Verdin iMX8M Mini

Errata Document

Figure 1: CAN Block Diagram

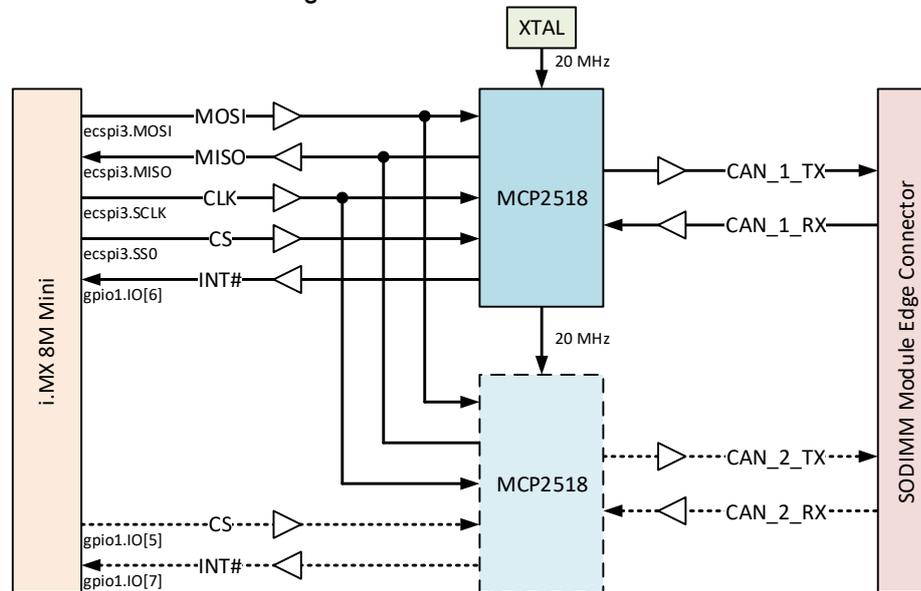
There are level shifters in the SPI signals between the SoC and the CAN controllers. If none of the CAN controllers are driving the MISO signal (both chip-select signals for the CAN controllers are deactivated), the MSIO signal can get to be floating. This means the MSIO signal is neither driven to GND or 3.3V and could cause an oscillation at the level shifter, which could cause a higher current draw than expected.

There is no software or hardware workaround available for V1.0 modules. A weak external pull-up is added on the modules with version 1.1 to avoid the MISO signal from floating.

Figure 2: Location of R28 and R29 (Top Side, Top View)

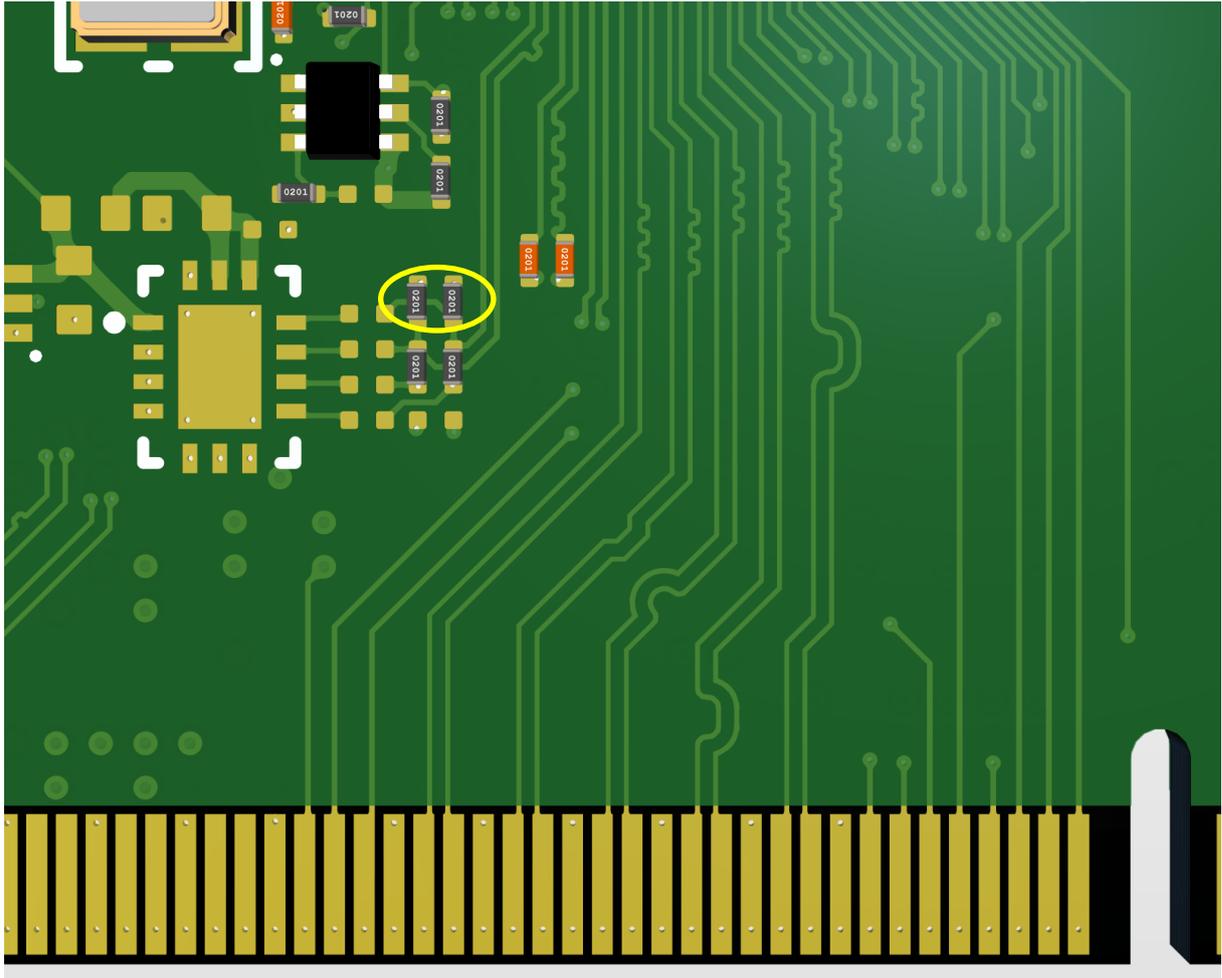
The voltage level of the PCIe reference clock output (PCIE_1_CLK_N and PCIE_1_CLK_P) is too low and not PCIe compliant. For some PCIe peripheral devices, the voltage swing is too small for those devices to operate properly.

The PCIe reference clock available at the module edge connector pins 226 and 228 is generated by the i.MX 8M Mini SoC. The clock signals are unintentionally terminated twice. There are 49.9Ω termination resistors on the module, and the SoC pins have internal terminations as well. This double termination adds too much load on the reference clock, leading to a wrong output level.

Remove the two 49.9Ω termination resistors R28 and R29 on the Verdin iMX8M Mini module. The resistors are located on the top side of the module.
